Access Compliance Report

Public Rights-of-Way

(Curb Ramps)

Intersection ID: 10014519	Main Street: UNIVERSITY_POINTE_BV	Cross Street: N/A	Location: NW
ADA ID: 0451D83CA60D	Ramp Type: Perp	Initial Pass/Fail: Fail	Overall Compliance: No
Severity Score: 10			
Codes/Mitigation Info/Possible Solution		Field Measurements/Component Compliance

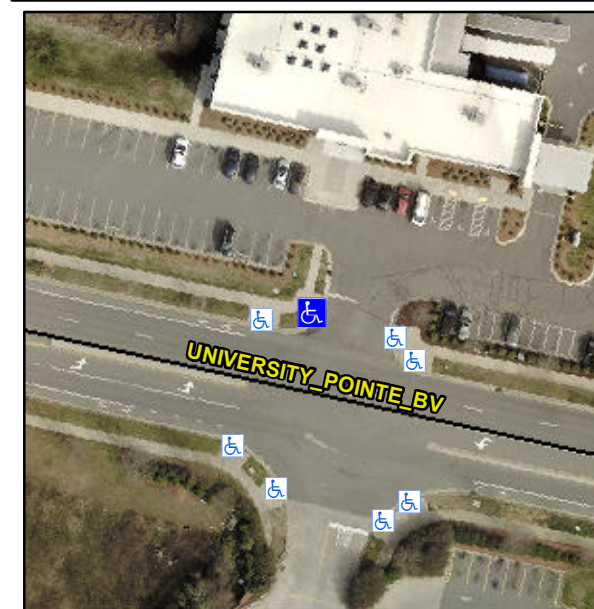
Not Found, R304.5.1, R304.5.3

Compliance	Description	Data	Compliance	Description	Data
N/A	Ramp Length (in)	96.0	Yes	Ramp Slope (%)	6.7
No	Ramp Width (in)	38.0	No	Ramp XSlope (%)	2.8
N/A	Flare Type LT	N/A	N/A	Flare Type RT	N/A
N/A	Flare Slope LT (%)	N/A	N/A	Flare Slope RT (%)	N/A
N/A	Flare Traversable LT?	N/A	N/A	Flare Traversable RT?	N/A
N/A	Landing Length (in)	N/A	N/A	DWS Provided?	N/A
N/A	Landing Width (in)	N/A	N/A	DWS Contrast?	N/A
N/A	Landing Slope (%)	N/A	N/A	DWS Length (in)	N/A
N/A	Landing X Slope (%)	N/A	N/A	DWS Full Width?	N/A
N/A	Landing Curb? (Y/N)	N/A	N/A	DWS Offset (in)	N/A
N/A	Shared Landing?	N/A			
N/A	Gutter Ponding?	N/A	N/A	Gutter Slope (%)	N/A
N/A	Gutter Lip Ht (in)	N/A	N/A	Gutter X Slope (%)	N/A
N/A	Painted X Walk1?	No	N/A	Painted X Walk2?	N/A
	X Walk 1 Direction	To E		X Walk 2 Direction	N/A
N/A	X Walk 1 Width (in)	N/A	N/A	X Walk 2 Width (in)	N/A
	X Walk 1 Slope (%)	3.5		X Walk 2 Slope (%)	N/A
	X Walk 1 X Slope (%)	2.1		X Walk 2 X Slope (%)	N/A

Remove & Replace Entire Ramp.
